Final 2017 Annual Sampling Report

Groundwater Monitoring and Data Analysis at the Landfill Source Area Operable Unit 4 Fort Wainwright, Alaska

REVIEW COMMENTS		PROJECT: Fort Wainwright, Alaska DOCUMENT: 2017 OU4 Monitoring Report		Location: Fort Wainwright , Alaska	
U.S. ARMY CORPS OF ENGINEERS		7 DATE: 7/13/18 REVIEWER: Erica Blake, ADEC PHONE: 451-2182	Action taken on comment by: Fairbanks Environmental Services Inc.		nc.

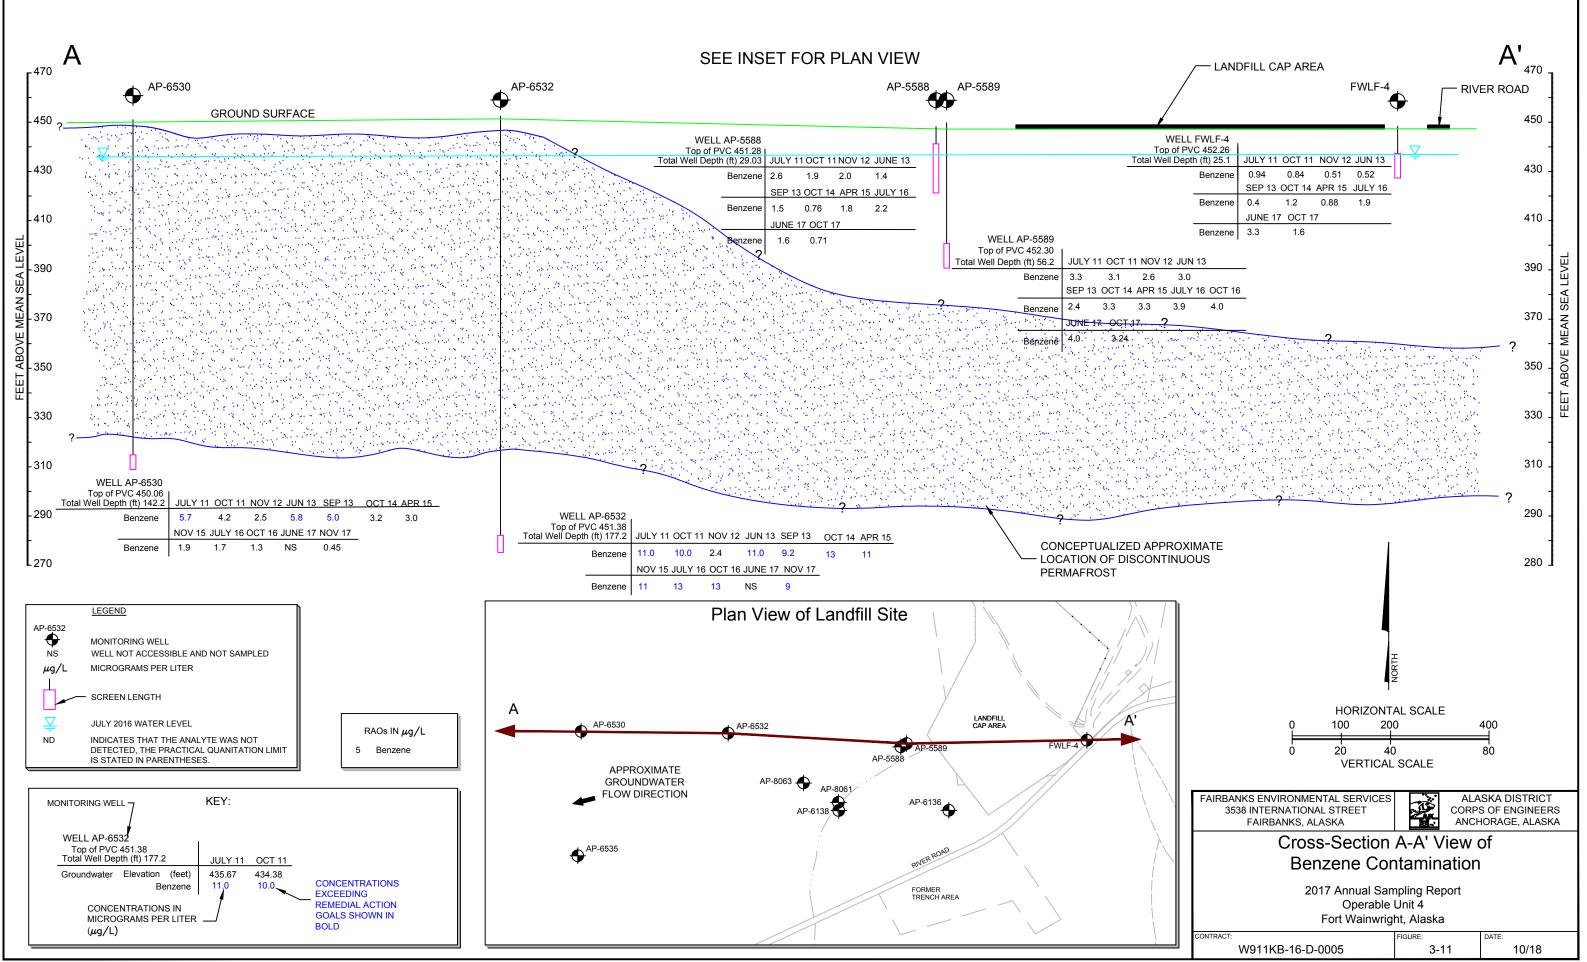
4.	Figure 2-1	Figure 2-1 should include the CAT shed, septic sys and leach pit. Please provide the location of these features on a figure in this report.	tem A	The requested features will be added to Figure 2-1.	Agree with comment back- check.
